City of Albuquerque Stormwater Construction Site Inspection Report

ECS	File:	F23 EUR

Re: Drainage Control Ordinance (14-5-2-1) Violations for Erosion and Sediment Control: 13305 La Arista Pl NE

Dirt pile in street being used as a ramp.

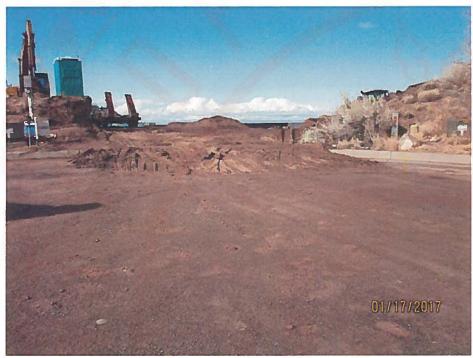
A dirt pile was being used to access the site, dirt is being tracked up the street and a filter sock was not being used to prevent dirt from entering the vegetated area.

- 1. Remove dirt ramp from the street. The contractor can use cold mix asphalt or lumber laid parallel to the curb for access.
 - 2. Remove dirt from the street. This is usually accomplished using a street sweeper.
- 3. Install a filter sock where the drainage leaves the cul-de-sac to prevent dirt from entering vegetated area.
